**Urgent Field Safety Notice**  
**Product Correction**  
Urgent - Immediate Action Required

**Alinity ci-series issues resolved in software version 2.6.0**

**Alinity ci-series hardware issues resolved**

Figure 1. Level Sensor, Bulk Solution identification label

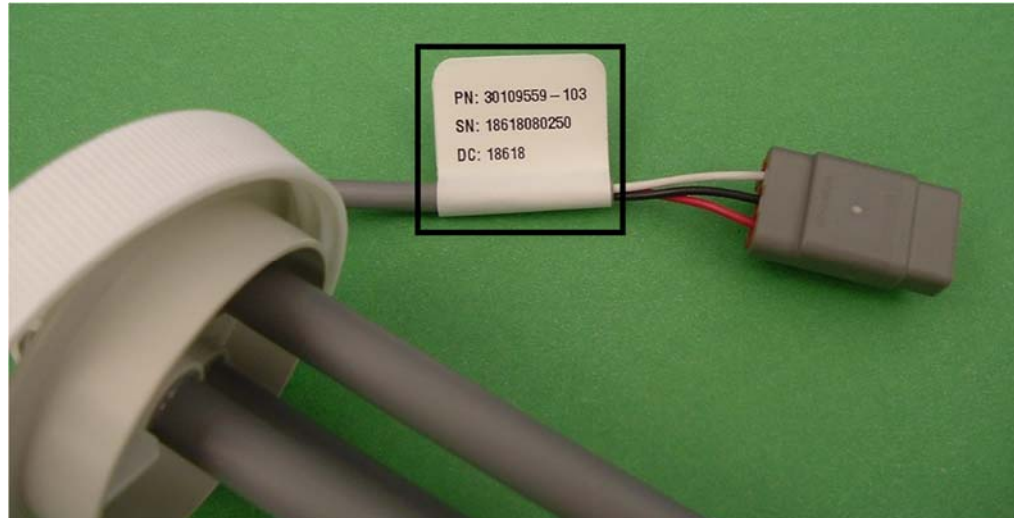
- If the part is in the box, the list number (04S68-01 or 04S68-02) is printed on the label
- If the part is removed from the box or installed on the Alinity ci series, the part number is printed on a label attached to the electrical connection for the part. See Figure 1 and Table 1 below.

List Number (LN)	Part Number (PN)	Instructions
04S68-01	30109559-102	Remove and replace any Level Sensor, Bulk Solution, LN 04S68-
04S68-02	30109559-103	01/PN 30109559-102 with LN 04S68-02/PN 30109559-103
